Magnet interference: main questions

May 6–8, 2003

Ring magnet layout

Magnet interferences

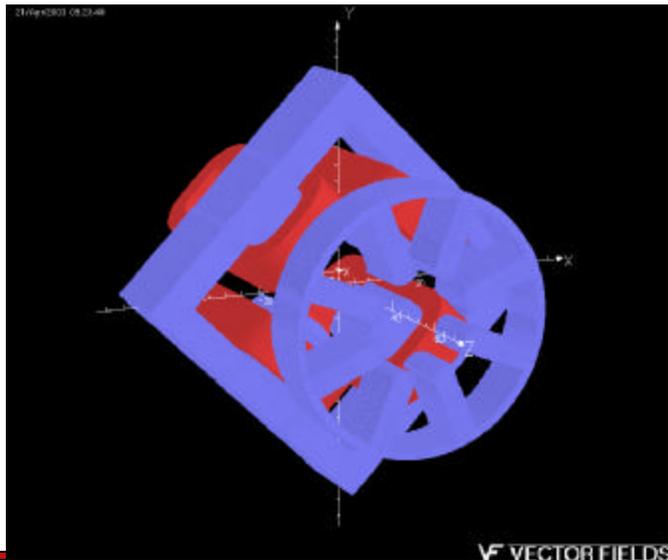
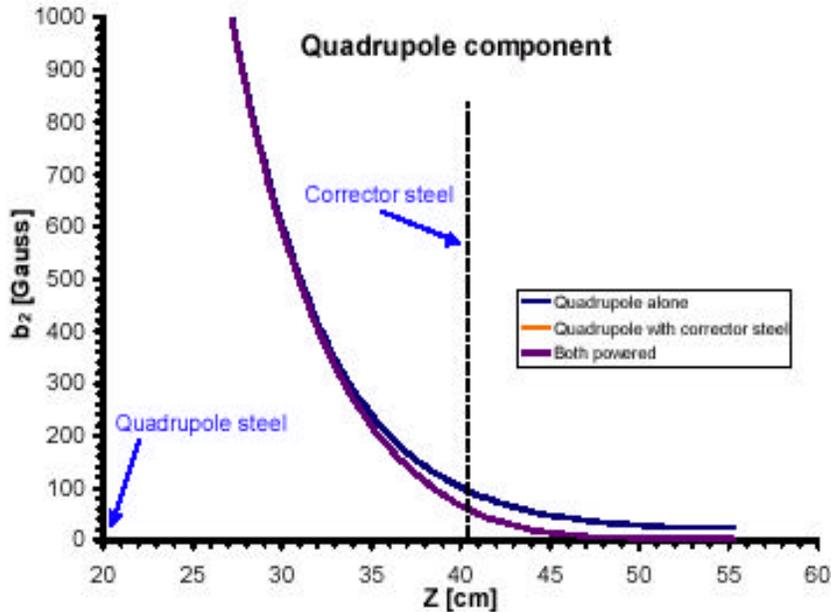
- Magnet layout
 - “gap separation” (20cm) as min.
- Hardware consideration
 - D on standoff stainless steel tubes
 - Q on s.s. subframe, Al spacer (30Q)
 - C, S on s.s. bracket
- Bench measurements (C, Q)
 - ITF change by $-(2.2 \pm 0.2) \times 10^{-3}$; systematic; confirmed by modeling 2.13×10^{-3}
 - Multipole variation below 1×10^{-4}
- Calculations
 - Modeling agrees with measurement
 - Multipole $< 10^{-4}$ with added 1” iron
- Ind. PS family layout & trim quad w/ PS
- Not an issue so far!
